ANDERSON WAREHOUSE - LOTS 1 AND 2

JOB TITLE:
ANDERSON WAREHOUSE

SHEET TITLE:
GRADING AND DRAINAGE PLAN

GRADING AND DRAINAGE

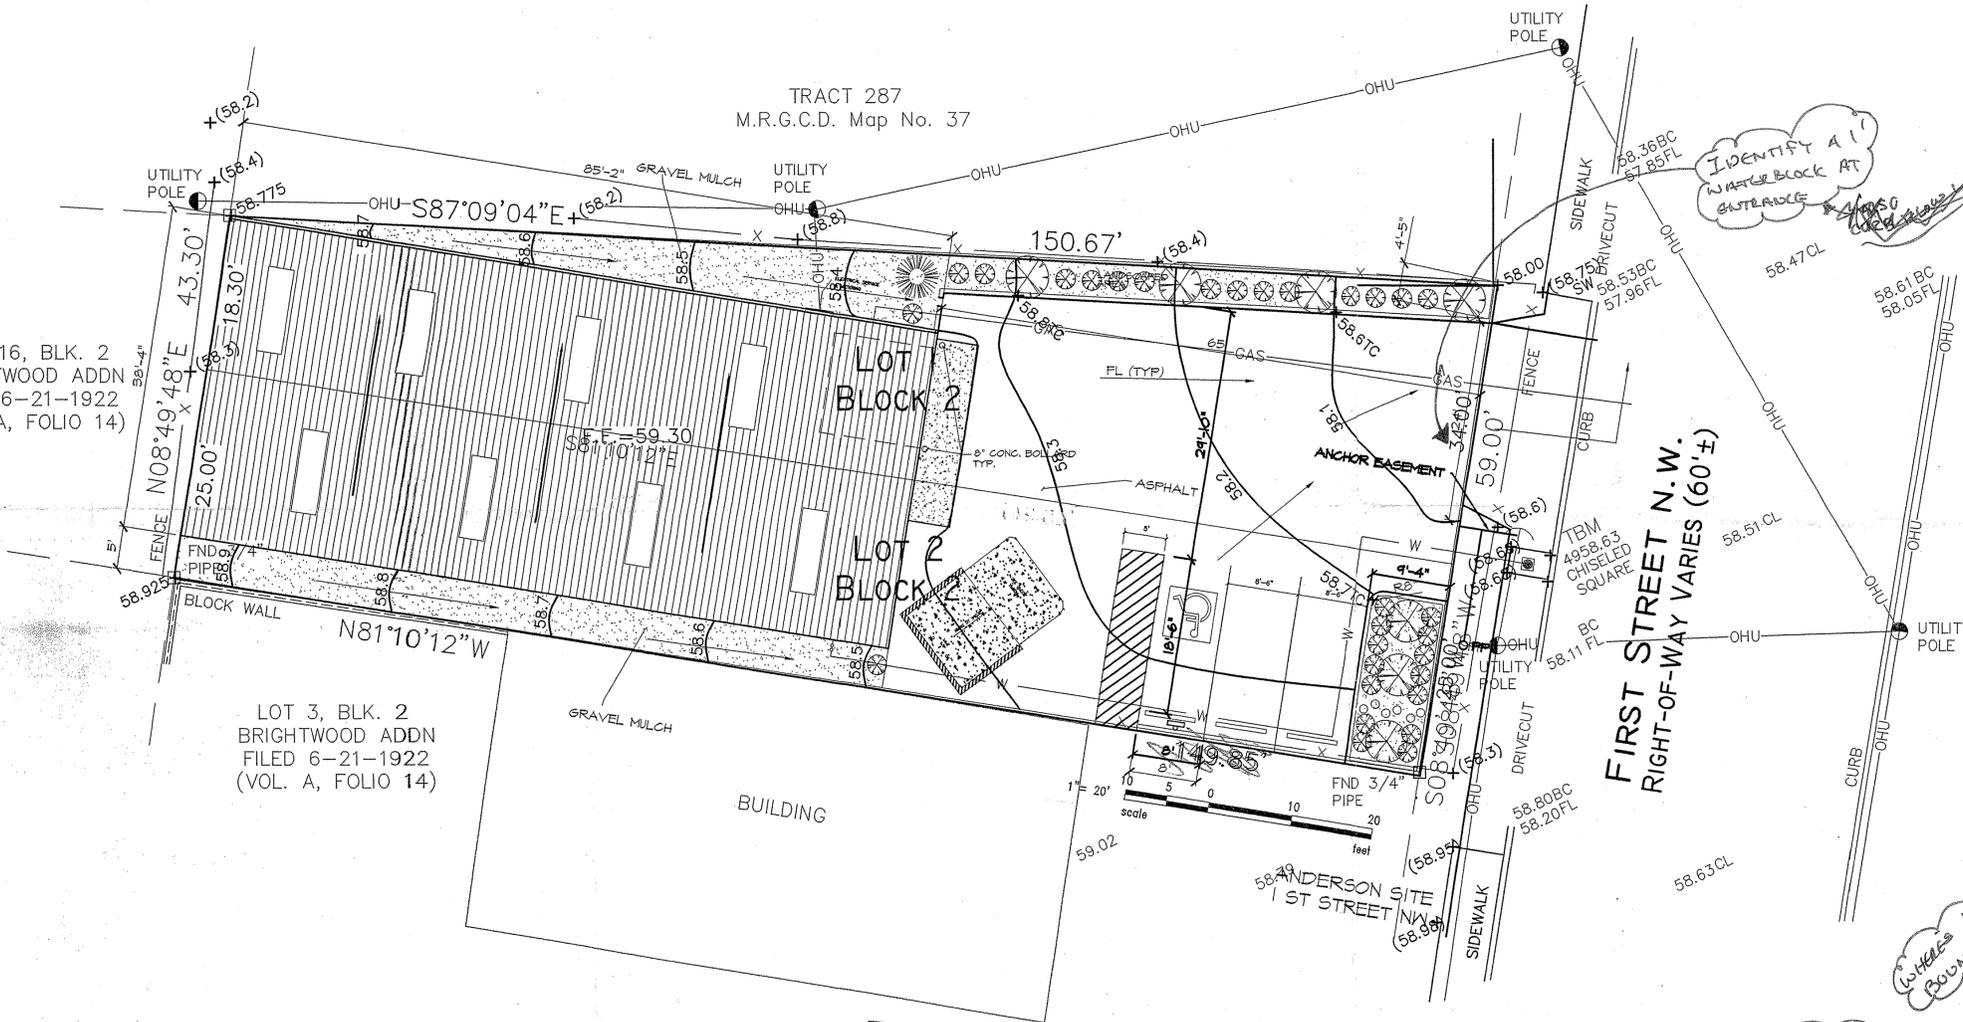
ARG LOTS 2 + 1
ARE THE SAME?
THE SAME?
OWNER?

NEED 25'
of CONTOURS AND
PROPERTY OUTSIDE
SITE
NOT GOOD INFORMATION

WHERE IS YOUR PROPERTY
BOUNDARY?

WHERE ARE THE
INLETS ON 1ST?
PLEASE PROVIDE
MASTER PLAN OR
BASIN MAP OF IT

IDENTIFY A 1'
WATER BLOCK AT
ENTRANCE

Proposed
Q point?
